**Economic and Social Council**Distr.: General
21 December 2018

Economic Commission for Europe**Inland Transport Committee****World Forum for Harmonization of Vehicle Regulations****177th session**

1958 Agreement:**Proposal for amendments to the Consolidated Resolution****on the common specifications of light source categories (R.E.5)****Proposal for amendment 3 to the Consolidated Resolution on
the common specifications of light source categories (R.E.5)****Submitted by the Working Party on Lighting and Light-Signalling***

Amendment 3 to the Consolidated Resolution on the common specifications of light source categories (R.E.5)

Figure 1
Main drawing

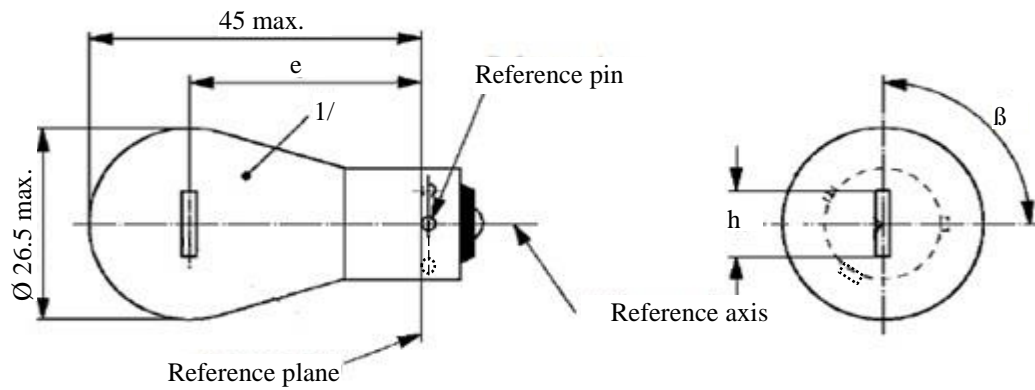
After sheet Lx5/6, insert new sheets PY21W/LED/1 to 4, to read:
(see the following pages; one page per sheet).

The drawings are intended only to illustrate the essential dimensions (in mm) of the LED light source.

Dimensions in mm		LED light sources of normal production			Standard LED light source
		min.	nom.	max.	nom.
e			31.8 ^{2/}		31.8 ^{2/}
h			9.0 ^{2/}		9.0 ^{2/}
β		75°	90°	105°	90°±10°
Cap [BAU15s-3(110°)] in accordance with IEC Publication 60061 (sheet 7004-[19A-1])					
Electrical ^{5/} and photometric characteristics					
Rated values	Volts	12	24	12	
	Watts	7 ^{3/}			7 ^{3/}
Test voltage	Volts	13.5	28.0	13.5	
Objective values	Watts	9 max. ^{3/}	10 max. ^{3/}	9 max. ^{3/}	
	Electrical current (in mA at 9-16V DC)	150 min. 750 max.			
	Luminous flux ^{3/, 4/} (in lm at 13.5 V DC)	280 ± 20 %			280 ± 10 %
	Luminous flux ^{3/} (in lm at 9 V DC)	56 min.			56 min.

¹ The light emitted from the LED light source shall be amber.
² To be checked by means of a "Box-System"; sheet PY21W/LED/2.
³ Operated in flashing mode for 30 minutes (frequency = 1.5 Hz, duty cycle 50 per cent ON, 50 per cent OFF) and measured in the ON-state of flashing mode after 30 minutes of operation.
⁴ The value measured at elevated ambient temperature of 80°C shall be at least 65% of this value.
⁵ In case of a failure of any of the light emitting elements, the LED light source shall either still comply to the requirements concerning luminous flux and luminous intensity distribution or stop emitting light whereby/in the latter case the electrical current draw, when operated between 12 V and 14 V, shall be less than 50 mA.

Screen projection requirements

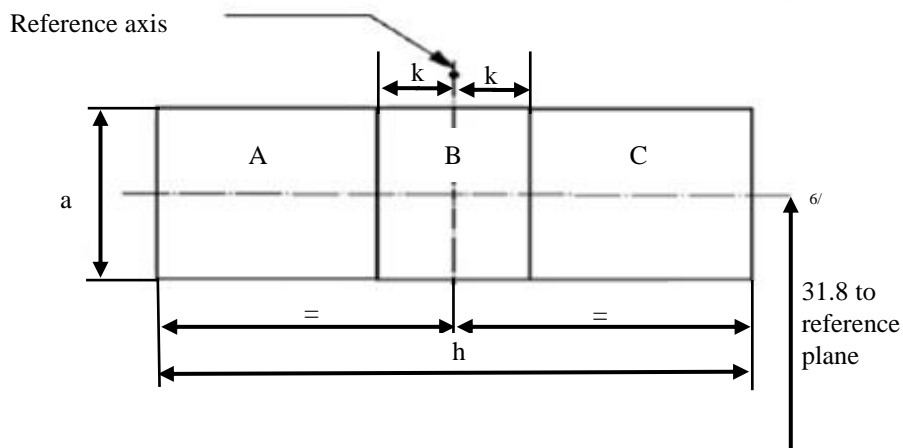
The following test is intended to define the requirements for the apparent light emitting area of the LED light source and to determine whether the light emitting area is correctly positioned relative to the reference axis and reference plane in order to check compliance with the requirements.

The position of the light emitting area is checked by means of a box system defined by the projections when viewing along direction $\gamma = 0^\circ$ (top view), $\gamma = \pm 45^\circ$ (inclined view) and $\gamma = \pm 90^\circ$ (front and rear view) in the plane C_0 (C, γ as defined in Figure 3).

The proportion of the total luminous flux emitted into these viewing directions from the area(s) as defined in figure 2:

- A, B and C together shall be 80 per cent or more;
- B shall be 25 per cent or more;
- A and C shall each be 15 per cent or more.

<i>Dimensions in mm</i>	<i>a</i>	<i>h</i>	<i>k</i>
Top view ($\gamma = 0^\circ$)	5.0	9.0	1.0
Inclined view ($\gamma = \pm 45^\circ$)	7.0		
Front / Rear view ($\gamma = \pm 90^\circ$)	5.0

Normalized luminous intensity distribution

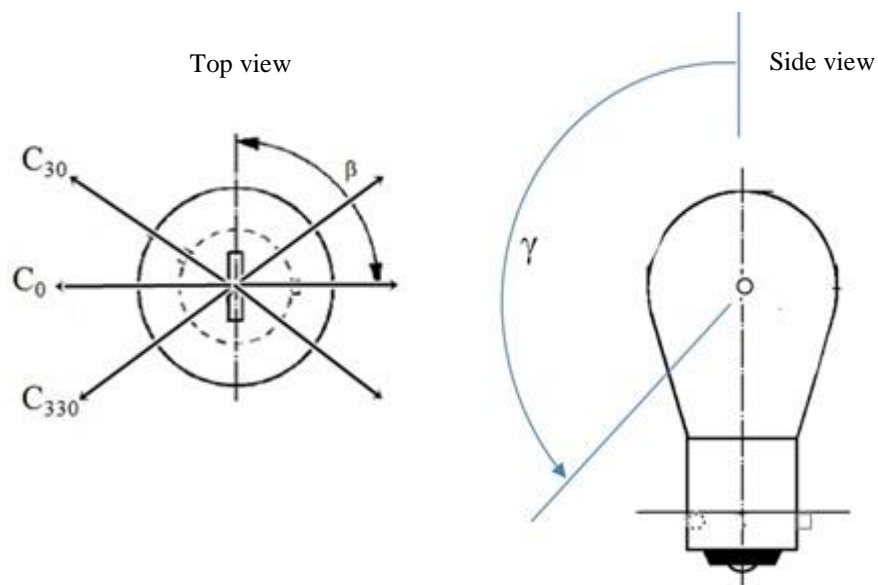
The following test is intended to determine the normalized luminous intensity distribution of the light source in the planes containing the reference axis as described in figure 3. The intersection of the reference axis and the edge of the box is used as the coordinate system origin.

The light source is mounted on a flat plate with the corresponding mounting lug features. The plate is mounted to the goniometer table by a bracket, so that the reference axis of the light source lines up with one of the rotating axis of the goniometer.

Luminous intensity data is recorded with a standard photo-goniometer. The measurement distance should be chosen appropriately, to make sure that the detector is located in the far field of the light distribution.

The measurements shall be performed in C-planes, which contain the reference axis of the light source. The C-planes shall be C_0 , C_{30} and C_{330} . The test points for each plane and multiple polar angles γ are specified in Table 3.

The measured luminous intensity values, normalised to the measured luminous flux of the individual light source under test, shall be converted to normalised luminous intensity values of a 1000 lm light source. These data shall comply with the tolerance band as defined in Table 3.
